**TOWN OF BAY HARBOR ISLANDS
MORRIS N. BROAD COMMUNITY CENTER**

**DEVELOPMENT & REVIEW COMMITTEE MEETING
THURSDAY, JANUARY 11, 2024**

**TOWN OF BAY HARBOR ISLANDS
COMMUNITY DEVELOPMENT
MEMORANDUM**

Subject: Site Development Plan Application (#2 Review)
New Multi-Family Residential Development (9 DU)
Applicant - 1160 101 St. Bay Harbor Condo 2618, LLC
1160 101st Street
Bay Harbor Islands Acct. No. SPR2023-000036
MMPA Acct. No. 01-0702-1178

BOUNDARY & TOPOGRAPHIC SURVEY	
1160 101 BAY HARBOR LLC.	
1160 101st STREET, BAY HARBOR ISLANDS, FL 33154

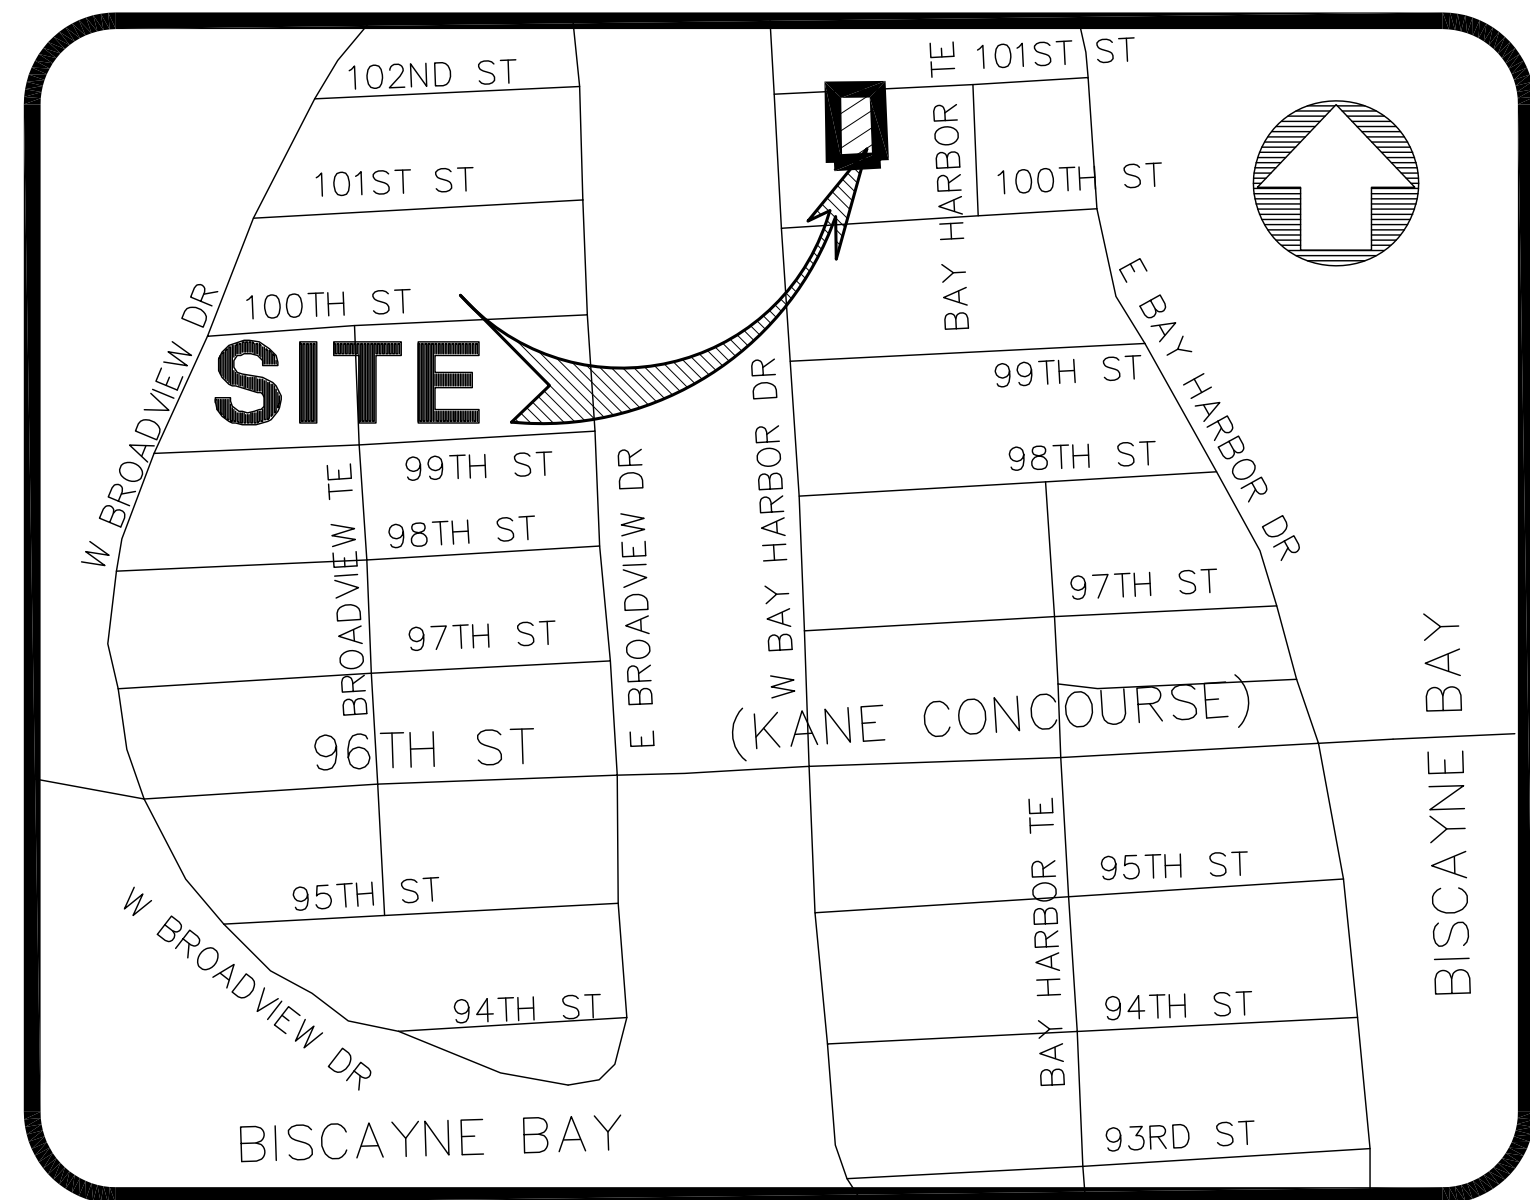
- 1) A tree survey of existing trees is a requirement for development approval. A tree survey was provided; however, the scale must be the same as the site plan and included an index of the tree species/ sizes / conditions. There is a Tree Disposition Plan as part of the Landscape Plans, but it is unknown how the specific tree information was obtained. **See revised Survey.**

TREE DISPOSITION
PLAN

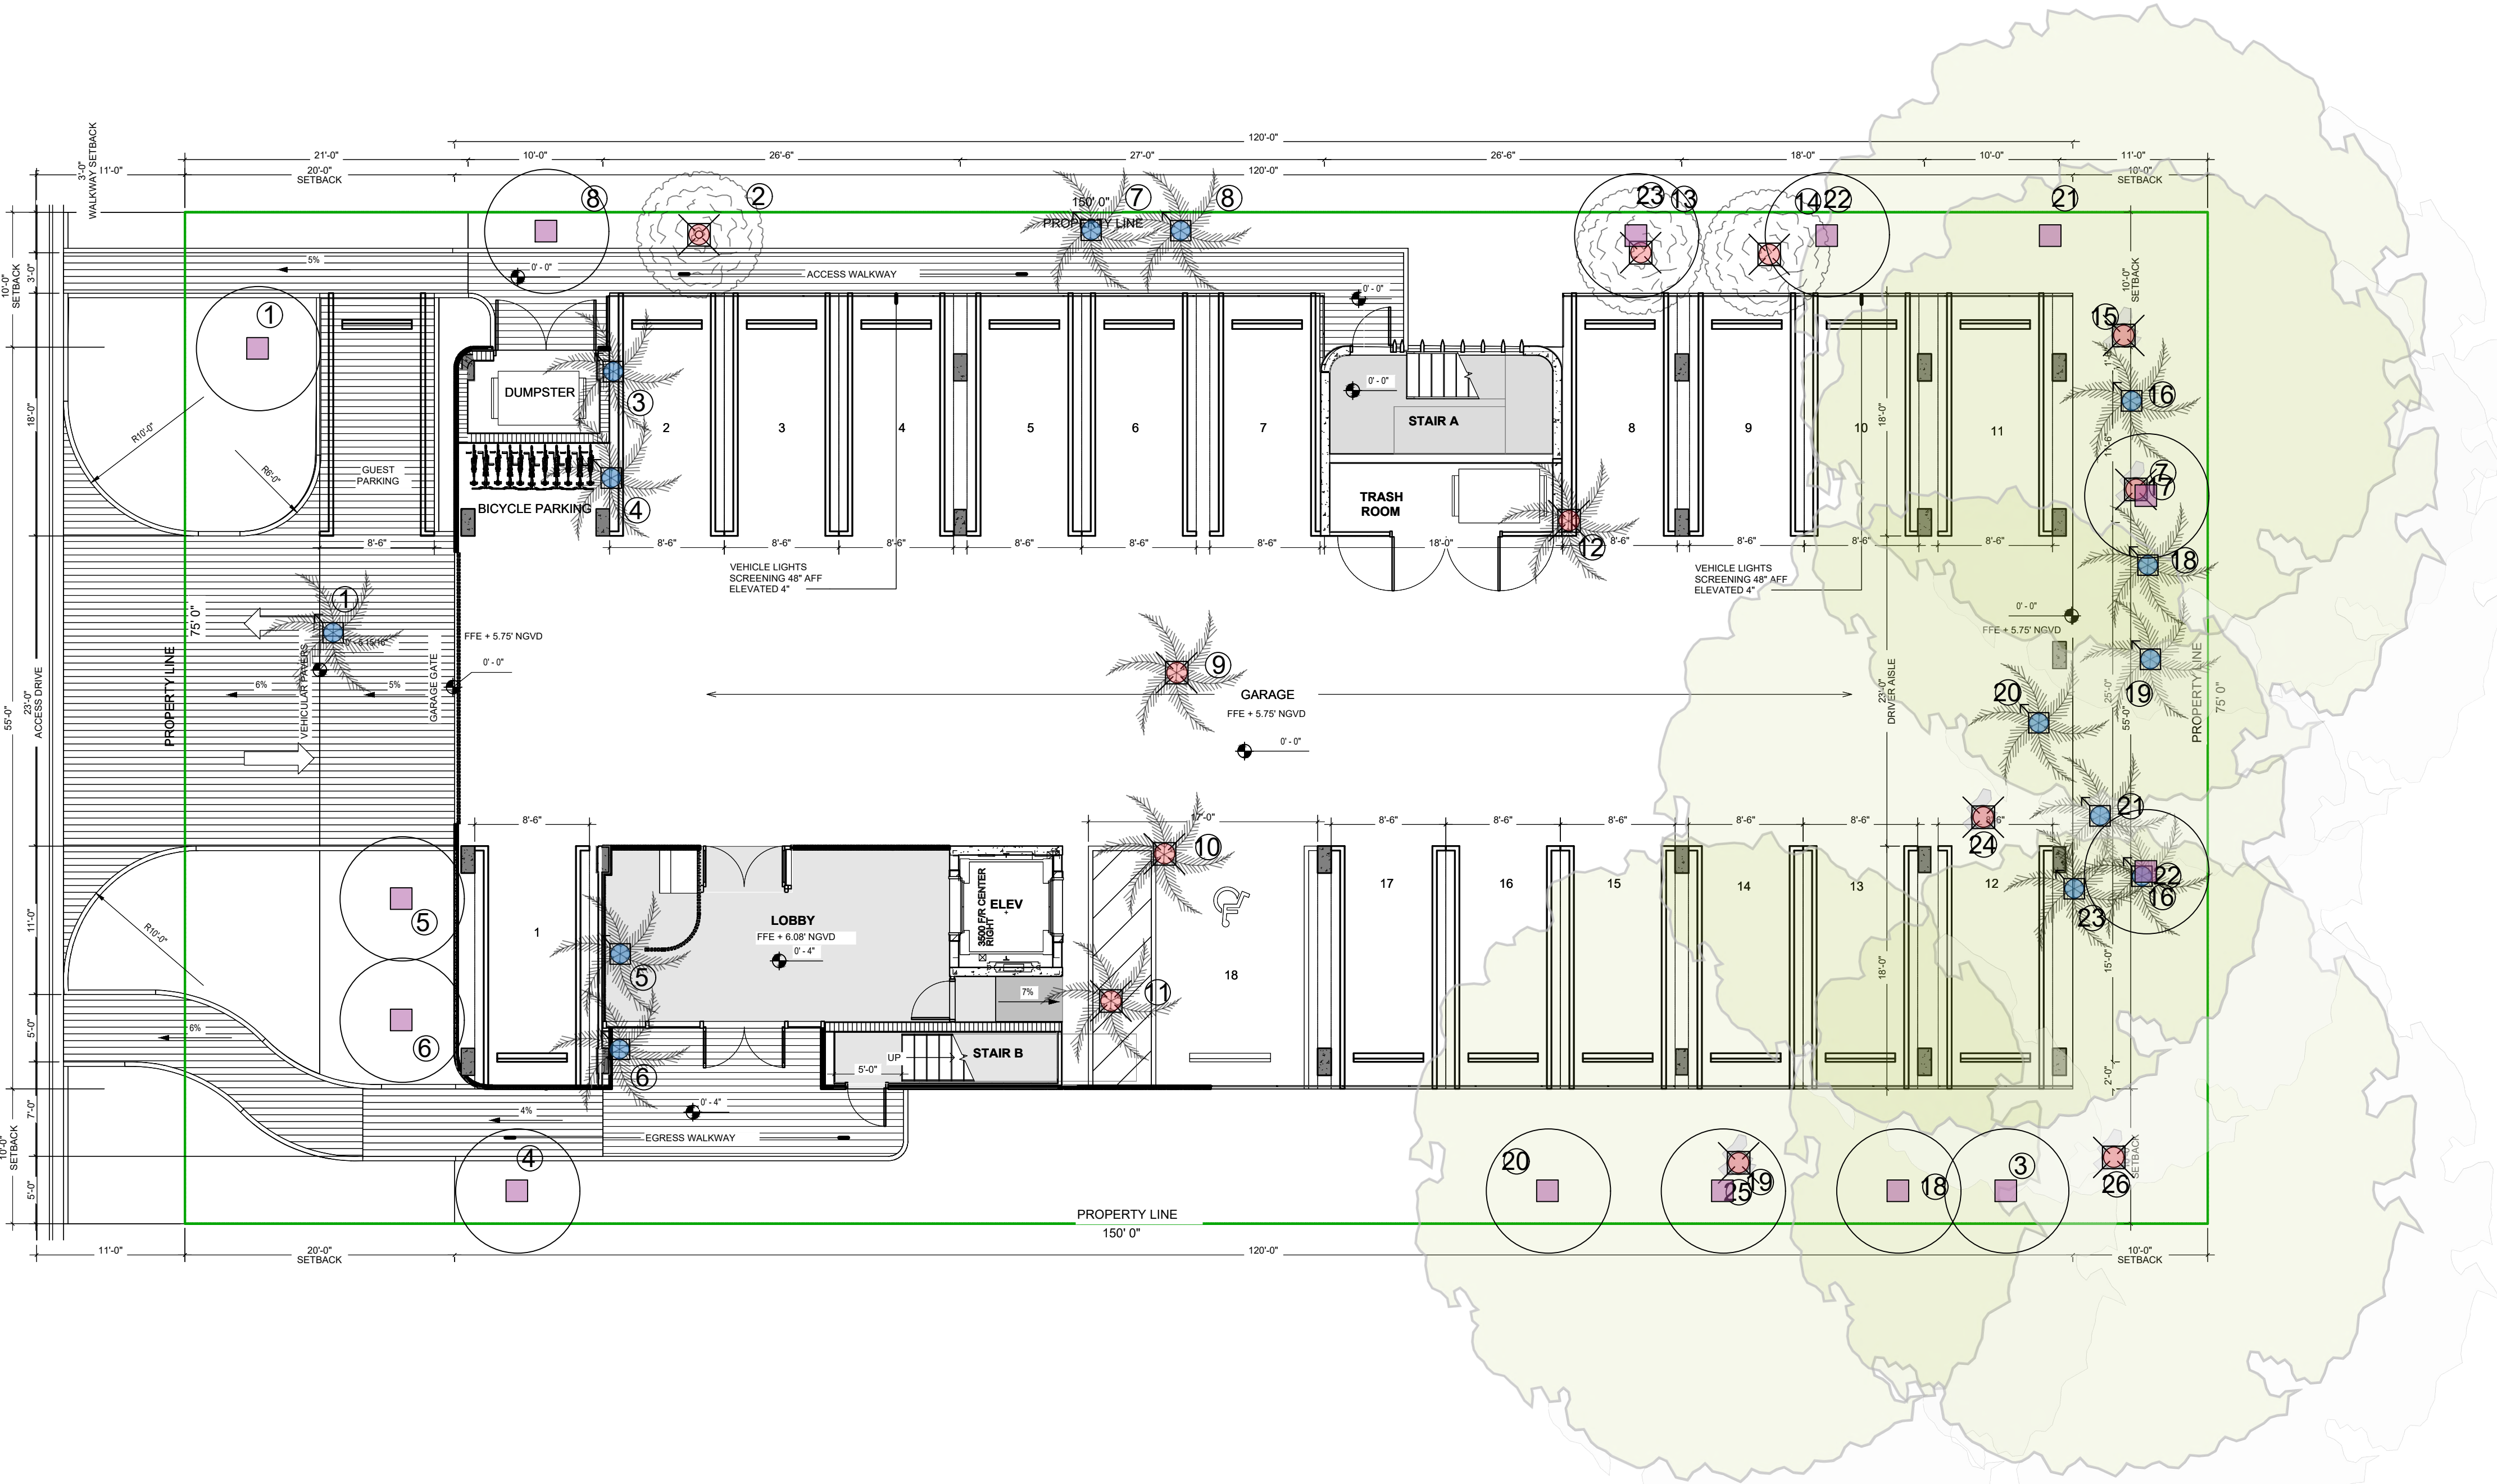
Sheets LA.00 & LA.01 were not revised to match the revised site plan & civil plan relocating the guest / drop-off parking space across the driveway near the lobby with a walkway.

LA.00

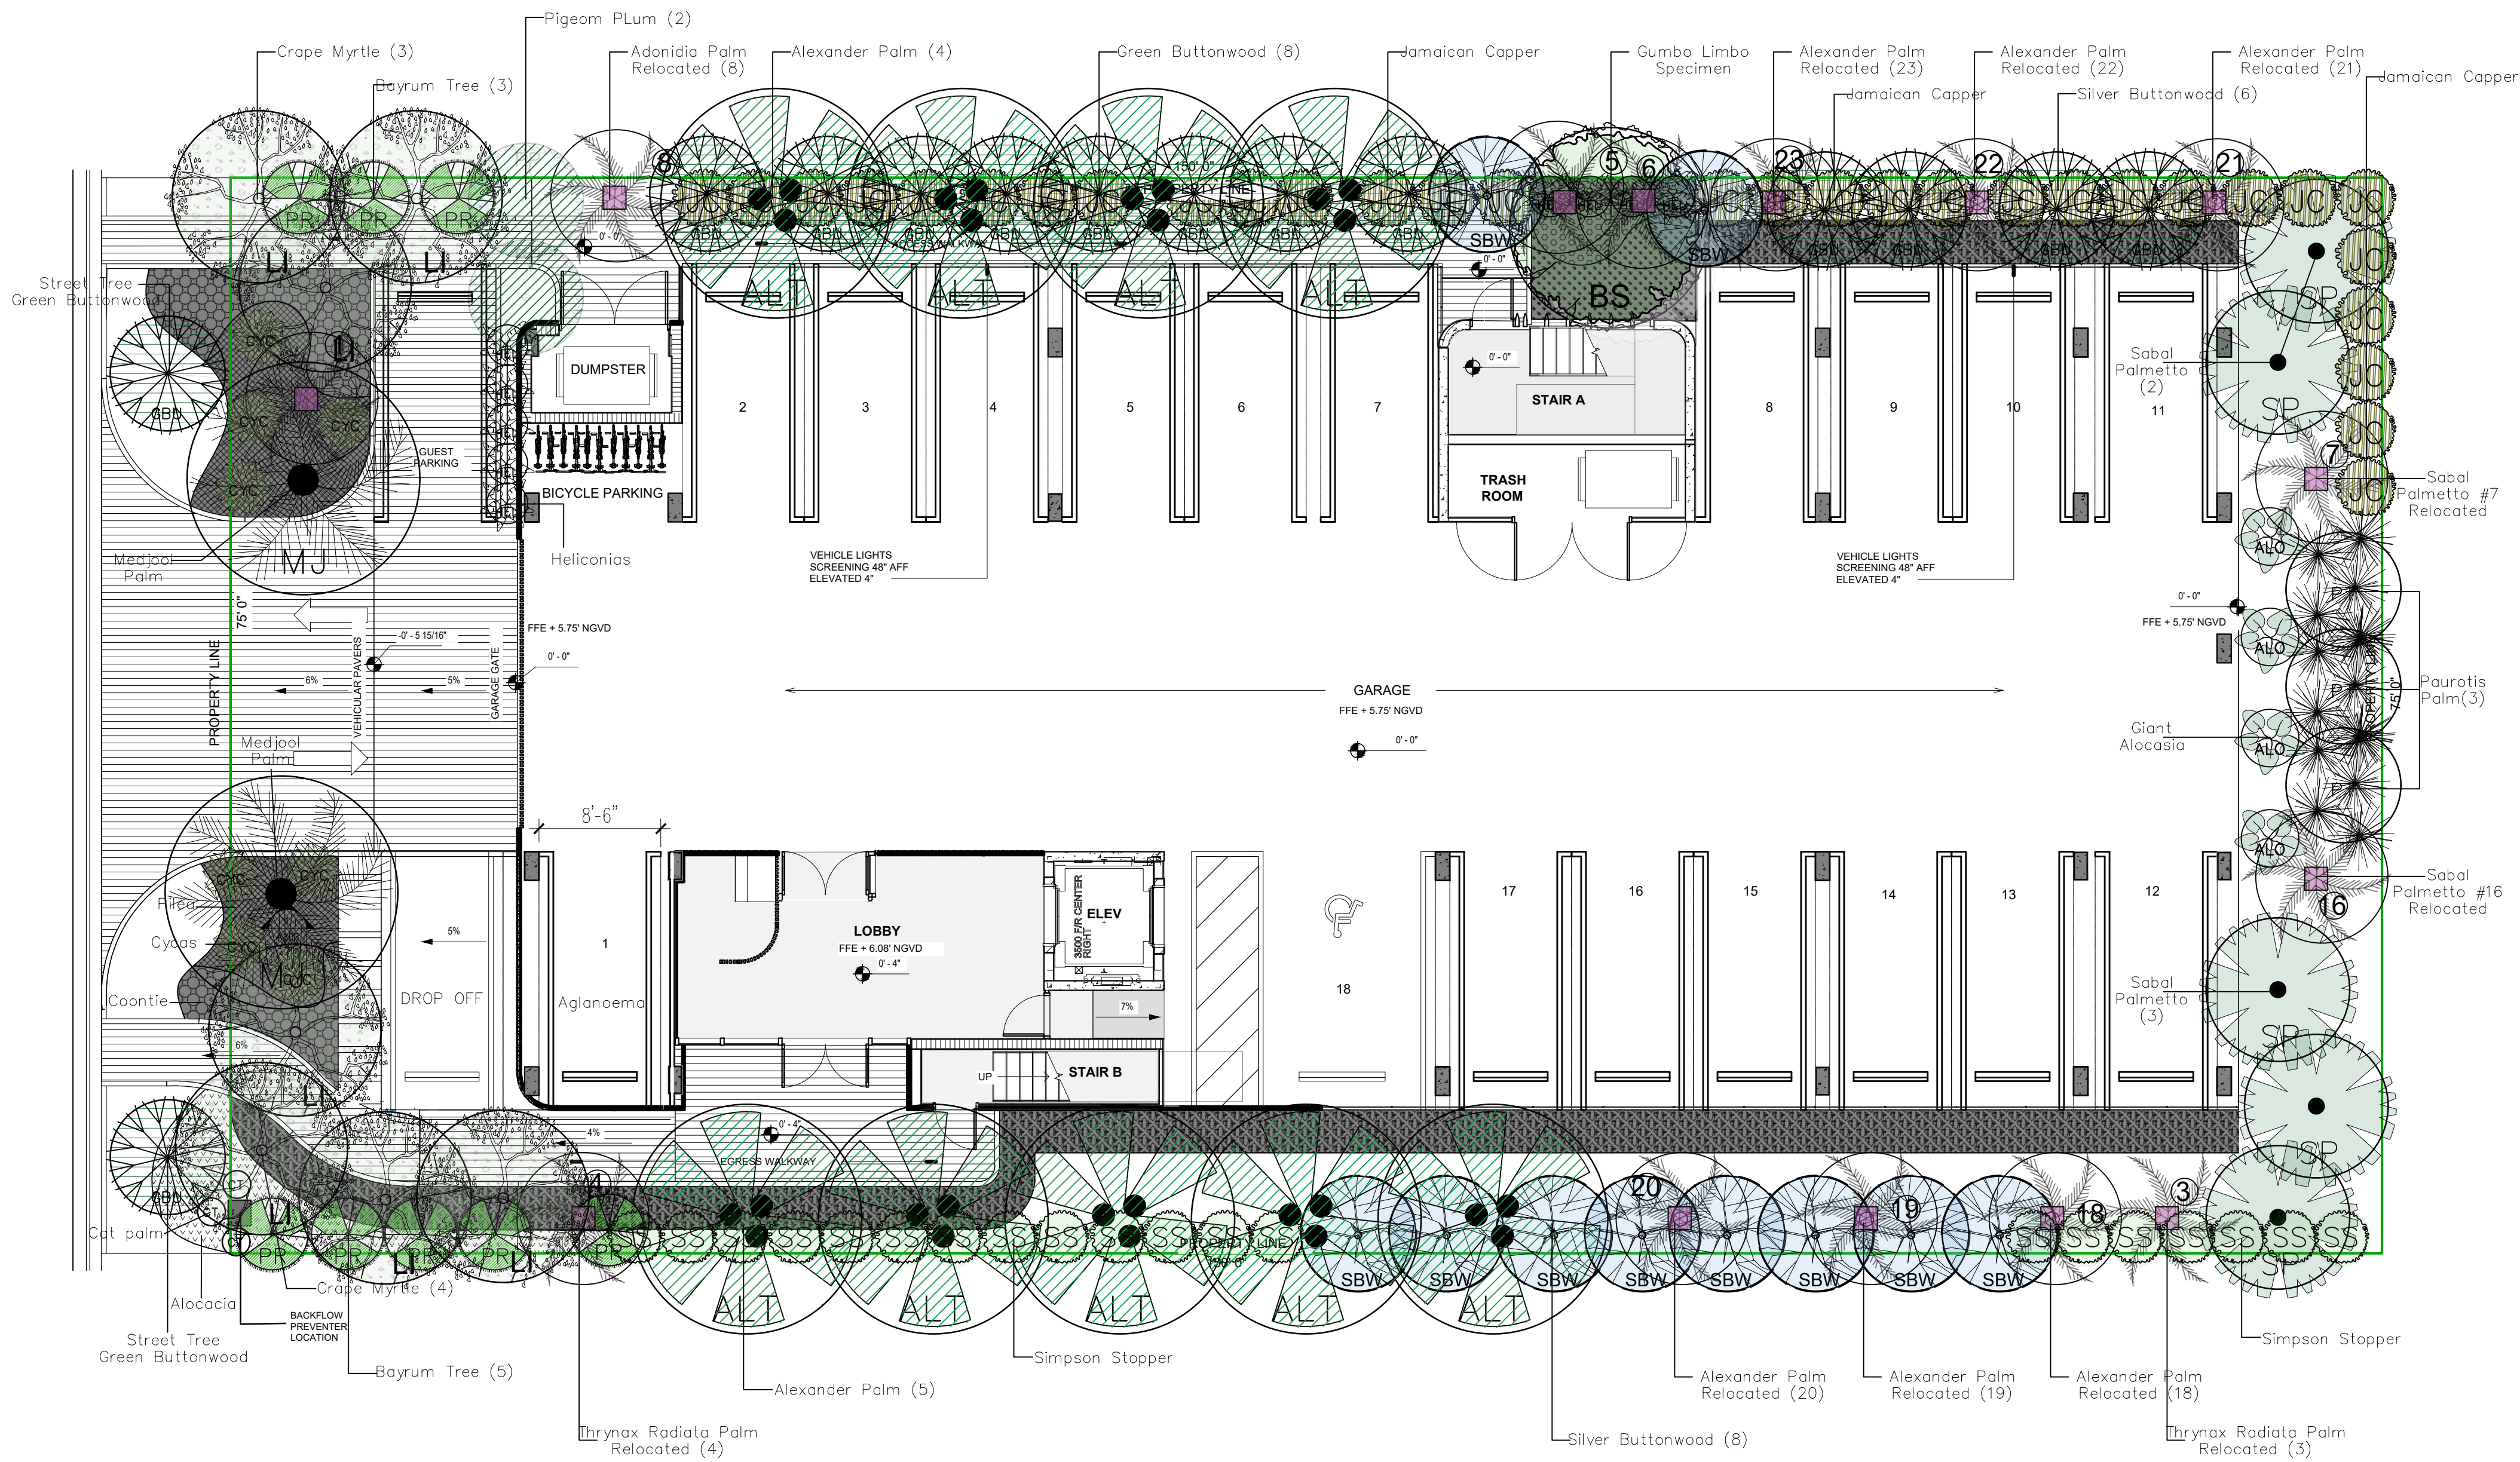
The Landscape Plan needs the following corrections:

1. **Backflow preventer/FCC is required to be screened from view on three (3) sides to allow access but screen the facility.**
2. **Street Trees - The Town's required Street Tree species for 101st Street is a Green Buttonwood. The Landscape Table shows Green Buttonwood, but the plan shows Silver Buttonwoods. Also, the minimum Town Street Tree size is 15' hgt. x 6' spread x 2.5n trunk caliper at time of planting. The plan shows 14' hgt.**

1. *Please, see the attached **Rev. Cloud 01** on sheet **LA.01** for location of Backflow preventer, screened from view on three (3) sides by 3.5' tall Alocasia species of shrub/groundcover. This allows for access but screens the facility.*
2. *Please see the attached **Rev. Cloud 02** on sheet **LA.01**. They have been corrected on plan to show Green Buttonwood street tree with minimum Town Street Tree size: 15' hgt. x 6' spread x 2.5n trunk caliper at time of planting.*
